**17061 WILD WAY - PROJECT DATA**

**New Construction at 17061 Wild Way.**

**RE: 17061 Wild Way**

**RECEIVED****ARCHITECT COMMENTS - Response**

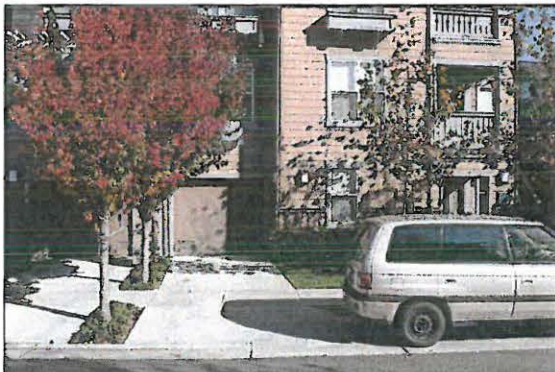
The proposed house is well designed with a recognizable architectural style and details consistent with its style. There are only a couple of issue as follows:

1. The front setback , at 25 feet, is 5 feet short of the required setback, and much smaller than others in the immediate neighborhood (see illustration below). While the side setback at the nearby house located across Wild Way at the southeast corner of the Wild Way/Oak Ridge Way intersection is relative small, street views to the facade are buffered with heavy landscaping. The frontage landscaping for the proposed house will be limited because of the primary 2-car garage access from Wild Way. Justification for the reduced setback has been stated as a desire on the part of the applicant and neighbors with whom the applicant has spoken to save as many of the large trees on the site as possible. The applicant is also providing some visual mitigation by recessing the garage and dividing it with two doors.

Recommendation: This is an issue that staff and the Planning Commission will need to make in balancing the benefits of a greater setback versus the retention of at least one of the large existing trees on the site. The only observation that I have is that a additional 5-foot of setback would probably not materially change the visual impact of the house. However, the applicant could reduce the footprint to meet the front setback requirement. Consideration could also be given to the planting of trees within the driveway, as shown in the two photos below, to add some buffer landscaping .

Another visual mitigation measure would be to add more refinement to the column caps and bases in front of the garage (see example photo below).

2. The corbels supporting the popouts on the front and right side elevation seem a bit small.

Recommendation: Increase the size of the corbels (see example photo on the following page).

3. The columns in front of the garage are lacking a traditional beam.

Recommendation: Add a beam per Residential Design Guideline 3.10.1 (see example photo below).

1. We have previously discussed the immediate neighborhood, which must include the front setbacks of at least some of the homes on Summit Way and Oak Ridge Way where 8 ft and 25 ft setbacks have been documented. The Consulting Architect has noted that increasing the front setback by 5 ft will have little impact on the visual impact of the home. However, more to the point, we have revised the driveway design to incorporate driveway trees as recommended. Please note that the garage is at the 30 ft setback and is 40 ft from the street, that the property is below the level of the street and that the mature oaks are twice the height of the home - all factors which diminish visual impact. We have also added column caps and bases at the garage front for now. We do not think that this is really in keeping with the Spanish Mission styling as we are proposing rough-hewn beams, but it is not a game changer. If planning staff agrees then we will remove these for the building submission, otherwise we will leave them as shown.

2. We have enlarged the size of the corbels to 6 x 10 lumber on the front and right elevations.
3. We have enlarged the traditional beam at the front of the house to make it more visible from the street.

**C4: Blue Oak 644**

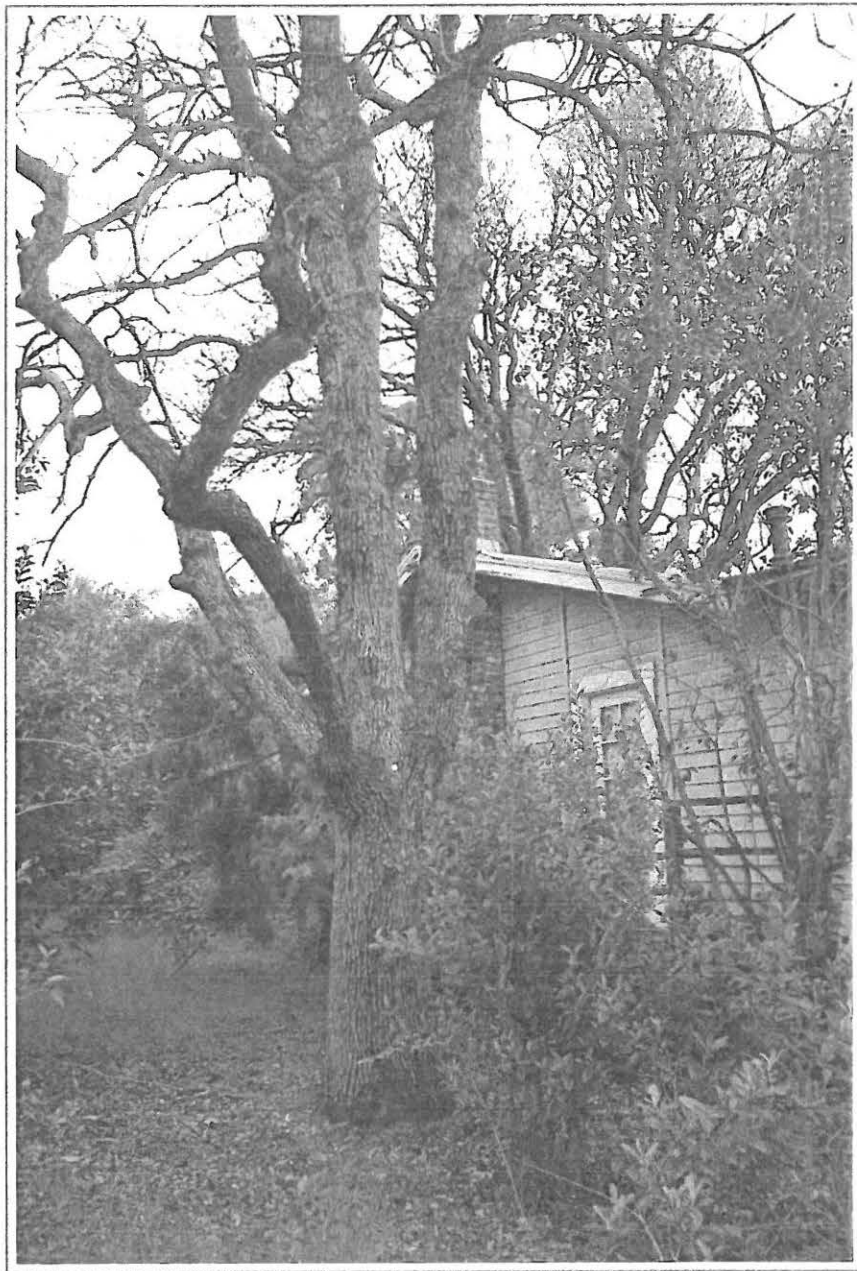
Regarding **tree #648**, it is a blue oak situated on the neighboring western property; the entire plane leans towards the street and utility pole supporting high-voltage electrical wires; there is extensive decay opposite the lean; and its canopy is sparse. In my opinion, this tree presents a serious threat to public safety and should be **immediately removed**.

My review of the proposed plans reveals the following, non-exempt **11 trees** are specified as removals: **#617, 621, 622, 624, 625, 634, 638, 642 and 644, 645 and 647**. Of these, **#621 and 647** are dead coast live oaks; **#617, 622, 624, 625, 634 and 645** have a low suitability; and **#638 and 644** have moderate suitability.
